対策箇所説明図

(その-2)

Pitman arm area

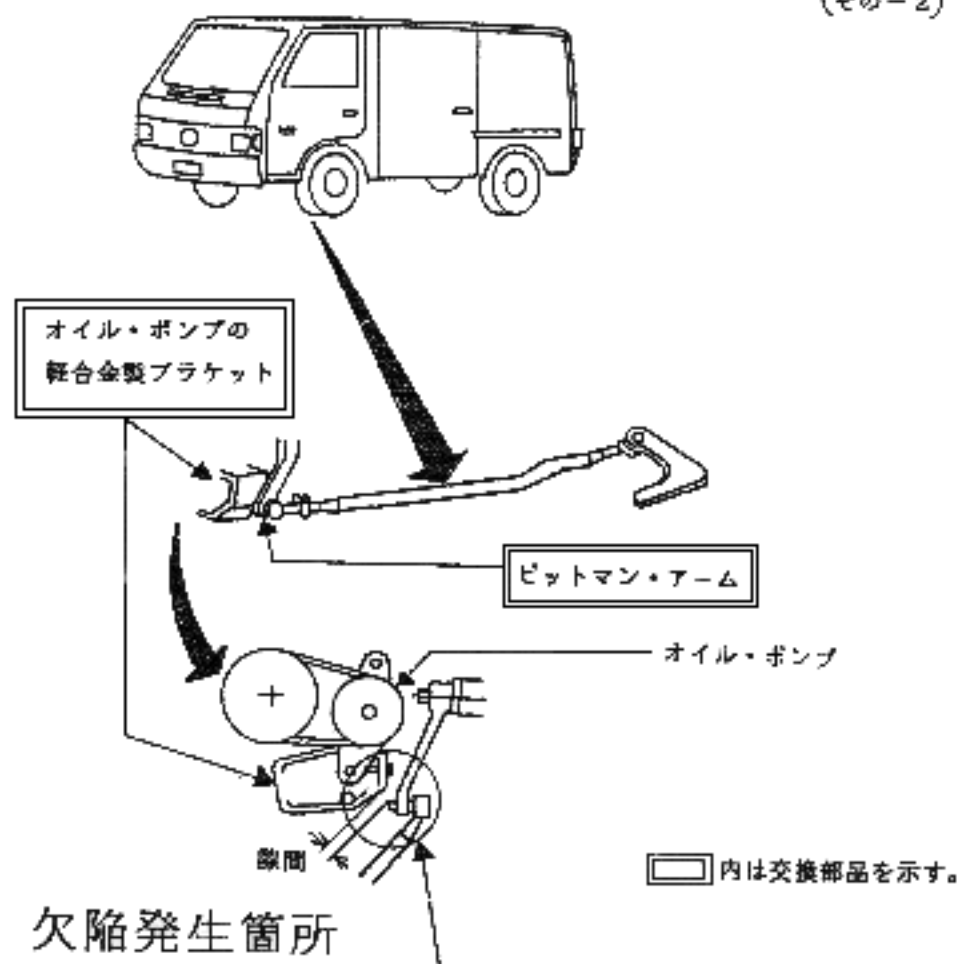
Oil pump's aluminum bracket and pitman arm have a very small gap, so they may contact when the handle is cut.

Replace the aluminum bracket of the oil pump and the pitman arm with the countermeasure product.
